**ROCKFORD BOARD OF EDUCATION
INVITATION FOR BID ON SUPPLIES, MATERIALS, EQUIPMENT OR SERVICES
FOR SCHOOL DISTRICT NO. 205
ROCKFORD, ILLINOIS**

IFB No. **17-40 Rockford Public School District 205 School B, Zone 1**

RE: **ADDENDUM NO. 8**

Rockford Public School District 205
School B, Zone 1
Rockford, IL
Cannon Project No. 005005.00

1. S0301 – TYPICAL FOUNDATION DETAILS

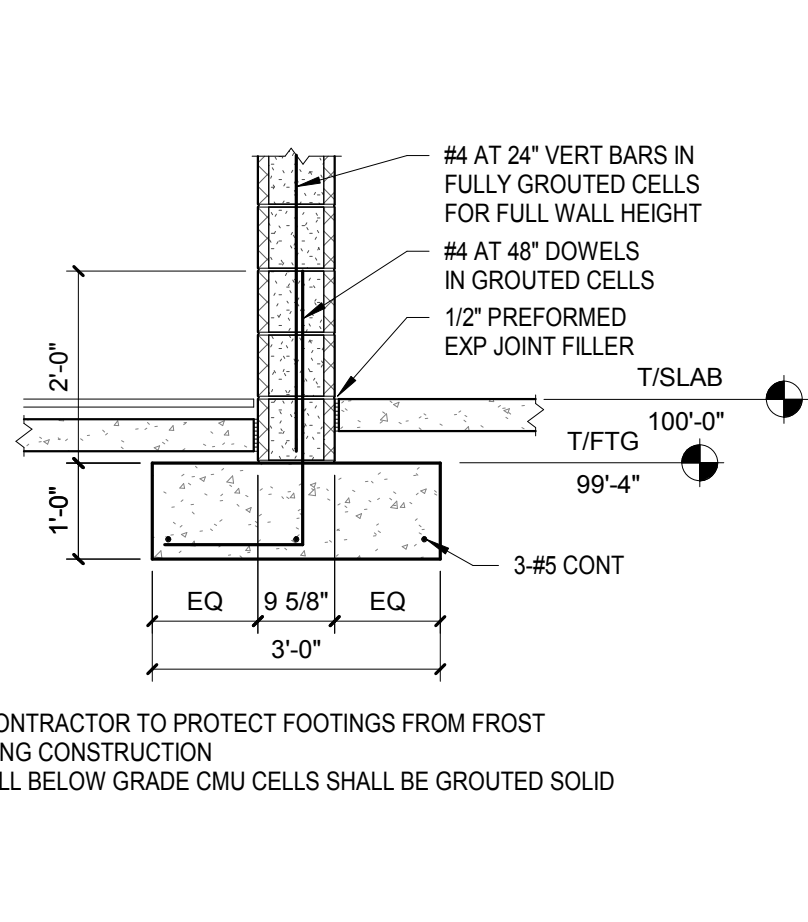
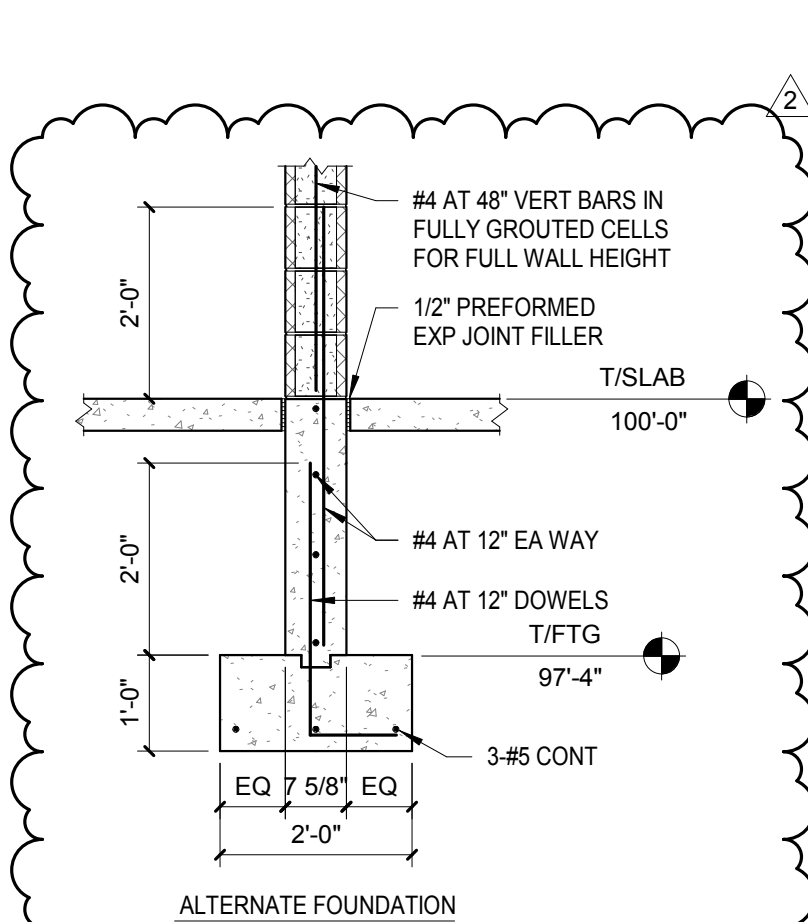
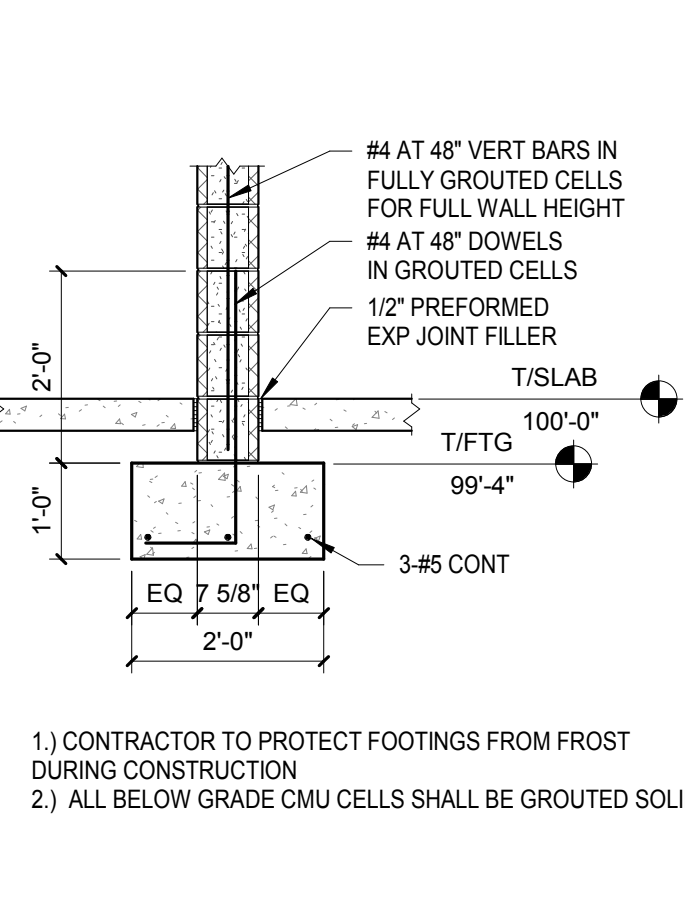
A. Drawing S0301 is being issued as an attachment to this Addendum to provide alternate details that the contractor may use at its option, in lieu of frost protection, to accommodate winter conditions and construction schedule.
